Request for Additional Information Response Letter

DEVELOPMENT APPLICATION DA2024/0826

Cass & Rob SIMS

71 Pitt Road, North Curl Curl, NSW 2099

Figure 1 View from no.71 looking southeast to Cocos Palms at no.14 Jamieson Avenue

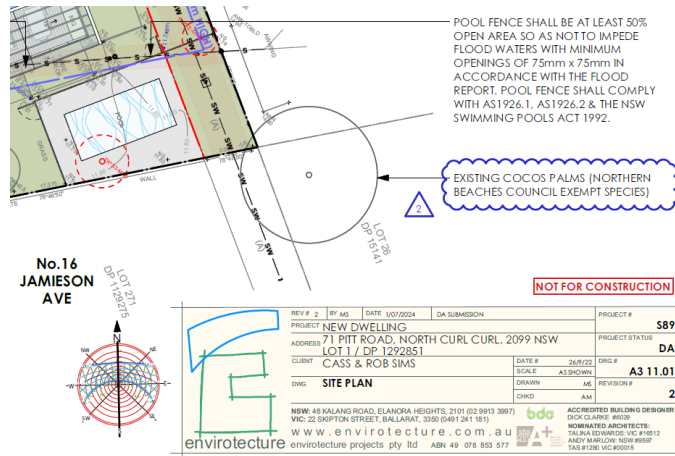
1. Clarification of Trees to be removed or impacted

An Arboricultural Impact Assessment Report, prepared by a qualified AQF5 (or higher) arborist, must be submitted when works are proposed within 5m of a tree irrespective of property boundaries, or a tree is proposed for removal. No Arborist Report is required for trees and species within the development site that can be removed without approval (i.e. Exempt Tree Species and trees under 5m in height).

In accordance with Northern Beaches Council Development Application & Modification Lodgement Requirements document, an Arboricultural Impact Assessment Report has not been commissioned on the basis that all trees within 5m of the proposed works are either exempt tree species or trees under 5m in height.

The documents have been revised to clarify that trees on the neighbouring lot to the southeast (no.14 Jamieson Avenue) are Cocos Palms which are listed as an exempt species on the Northern Beaches Council Exempt tree species list. Refer figures 1 & 2.
